**MEMORANDUM**

**TO:** District of Columbia Board of Zoning Adjustment  
**FROM:** Samuel Zimbabwe  
Associate Director  
**DATE:** April 21, 2016  
**SUBJECT:** BZA Case No.19289 – 5505 5th Street NW (Ward 4 Emergency Shelter)

Figure 4- Weekday Evening Parking Utilization (Source: Gorove/Slade)

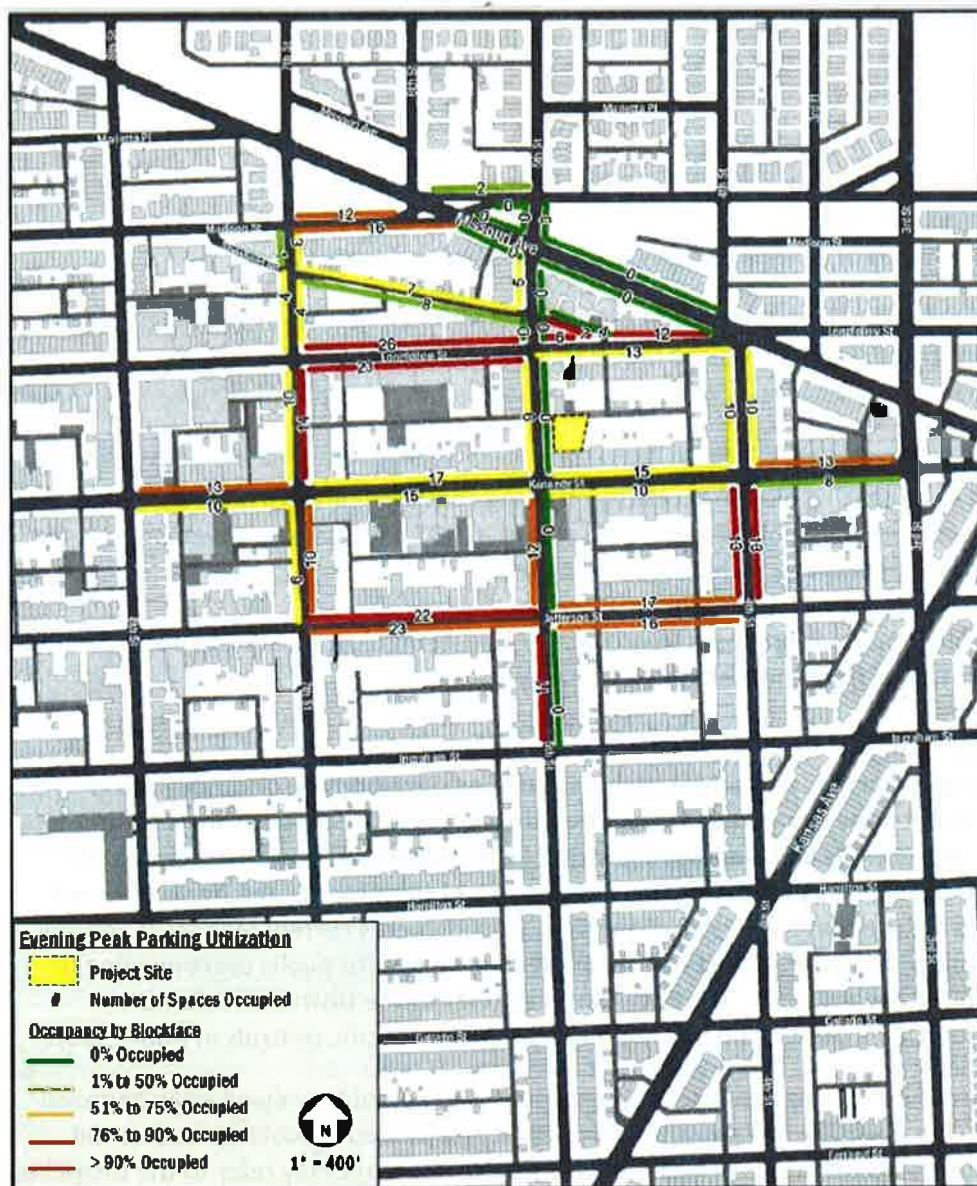
The Applicant performed a parking occupancy study on Wednesday, June 8, 2016, at hourly intervals from 5:00pm to 11:00pm, to determine if the surrounding street network had the capacity to meet parking demand for 19 spaces. The study was conducted within a 600 to 900-foot walkshed of the site and found that during 10:00pm to 11:00pm when peak occupancy was observed, there are approximately 156 available on-street parking spaces out of 606 spaces. The study concluded that the on-street parking supply has the capacity to meet parking demands generated by the staff use.

Parking occupancy was studied during the evening when parking is in higher demand by residents. DDOT expects higher parking availability during the morning and afternoon. As such, DDOT finds parking supply should be appropriate to meet demand.
